Next Export Zone Ltd.

24th Feb 2020

Observations

Undocumented water tanks and non-engineered supporting structure on the roof

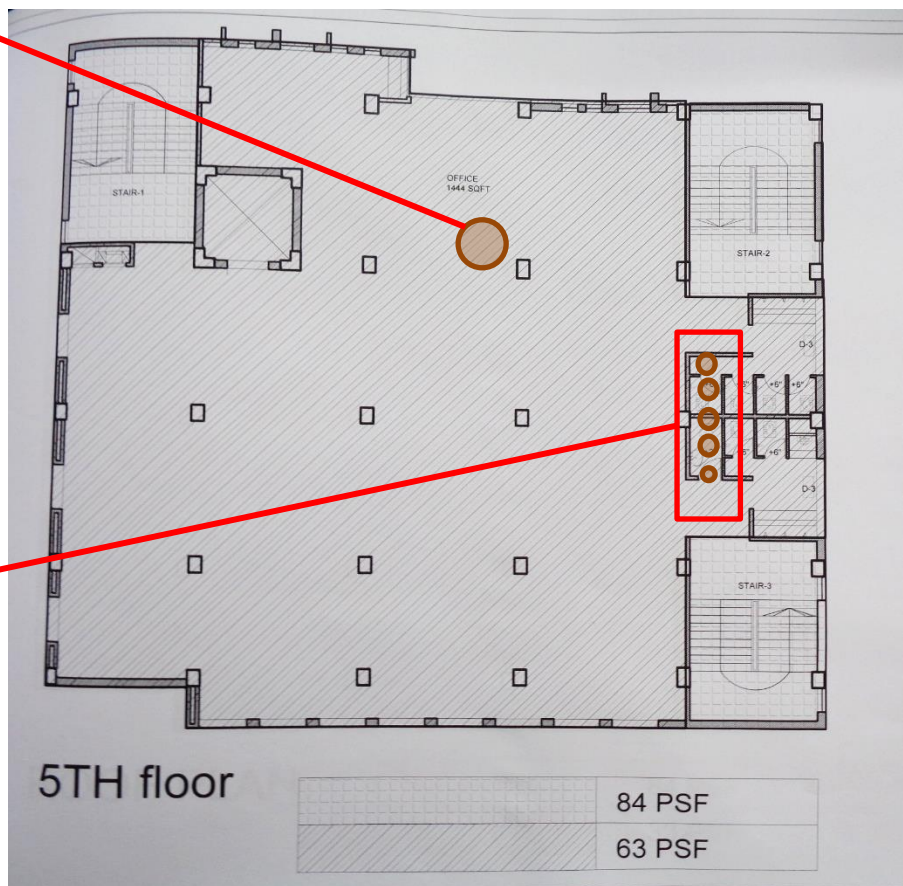
Undocumented 5000 Ltr water tank

Undocumented 4 nos 1000 Ltr and 1 no 750 Ltr water Tank

Undocumented water tanks were found on existing roof. Also a non-engineered supporting structure was found at roof level. Factory engineer is required to survey and update the as-built condition.

Mismatches in the design report and software analysis file

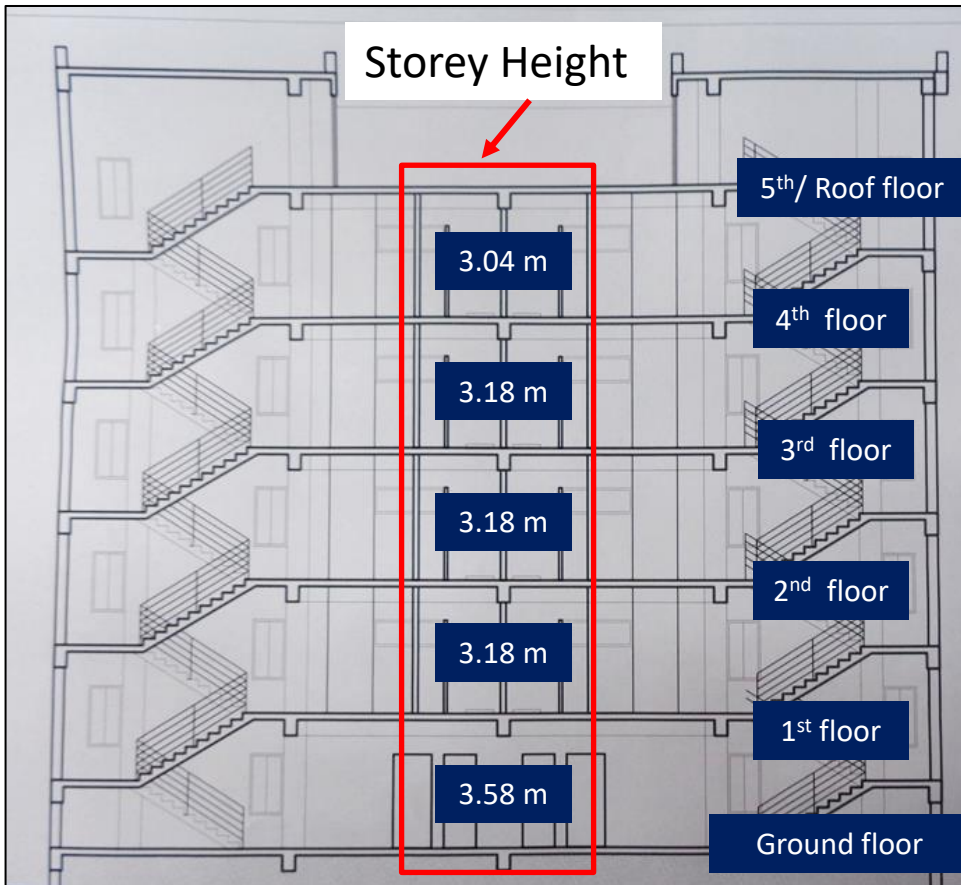
Column size has been shown in drawing: 1- 457mm X 584mm; 2 & 3 – 406mm X 508 mm

C5 Column Size found in FEA model:
1- 457 mm X 685 mm; 2 & 3- 406 mm X 609 mm.
The column sizes in the FEA model are greater than sizes shown in the provided drawings.
The factory engineer to verify the actual sizes of columns and re-check the capacity accordingly.

Storey Height of 6 storied building in E-tabs

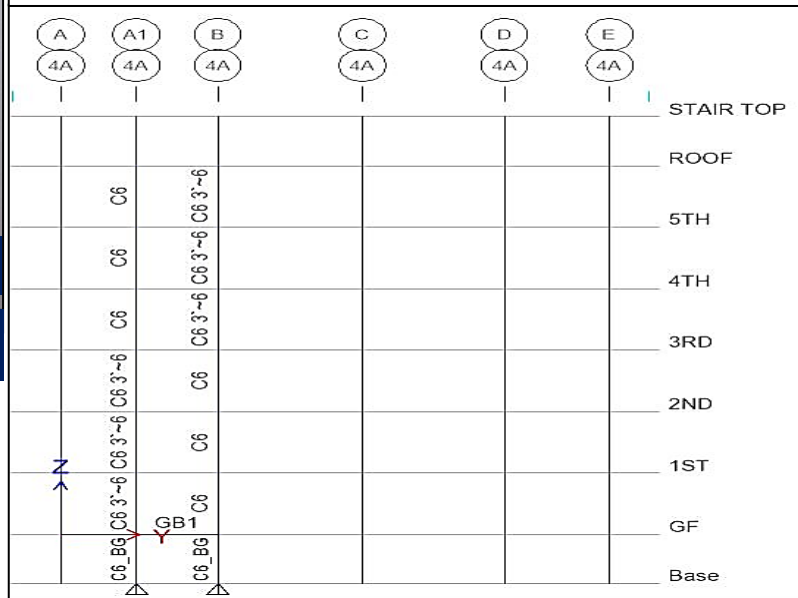
Storey height and number of the storey found mismatch in between FEA model and as-built drawing. Also, in the as-built drawings, the structure has been shown as 5 storied RC structure where 6 storied in the FEA model.
